Well Name: S BLANCO NAV 8	Well Location: T23N / R7W / SEC 8 / NENE / 36.248047 / -107.588882	County or Parish/State: RIO ARRIBA / NM
Well Number: 1	Type of Well: OIL WELL	Allottee or Tribe Name: EASTERN NAVAJO
Lease Number: N00C14205607	Unit or CA Name:	Unit or CA Number:
US Well Number: 300392254800S1	Operator: DUGAN PRODUCTION CORPORATION

Notice of Intent

Type of Action: Plug and Abandonment

Notice of Intent – Plug and Abandonment

Planned P & A Wellbore Schematic

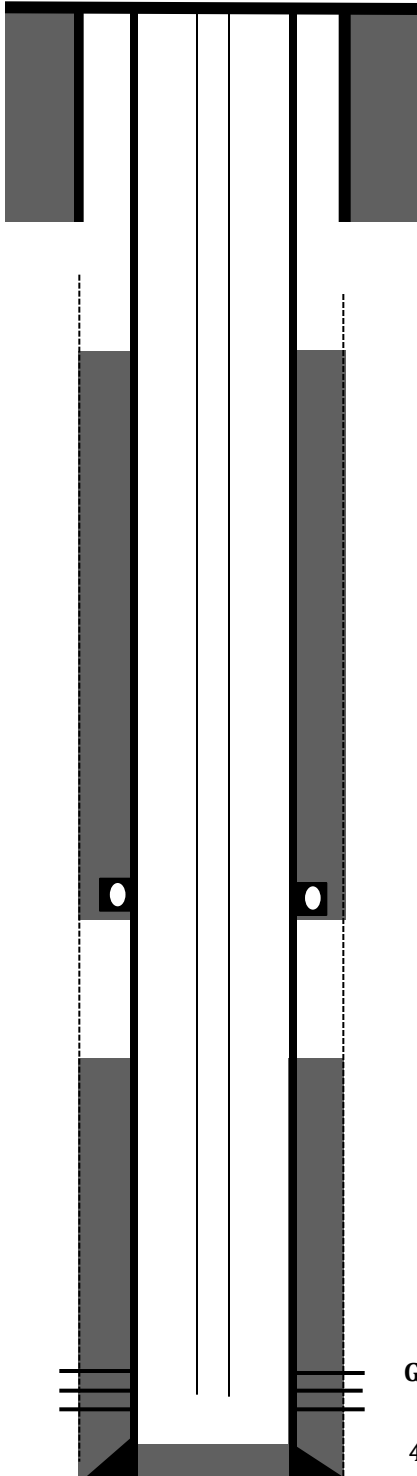
1. Plugging operations authorized are subject to the attached "General Requirements for Permanent Abandonment of Wells on Federal and Indian Lease."
2. The following modifications to your plugging program are to be made:
 - a. Plug 4 should be adjusted to cover 100' above BLM geologist pick for the Fruitland at 1670'. It is recommended to combine Plug 4 and Plug 5.
3. **Notification:** Farmington Office is to be notified at least 24 hours before the plugging operations commence at (505) 564 7750.

Remarks: Plug 4 should be adjusted to cover 100' above BLM geologist pick for the Fruitland at 1670'. It is recommended to combine Plug 4 and Plug 5.
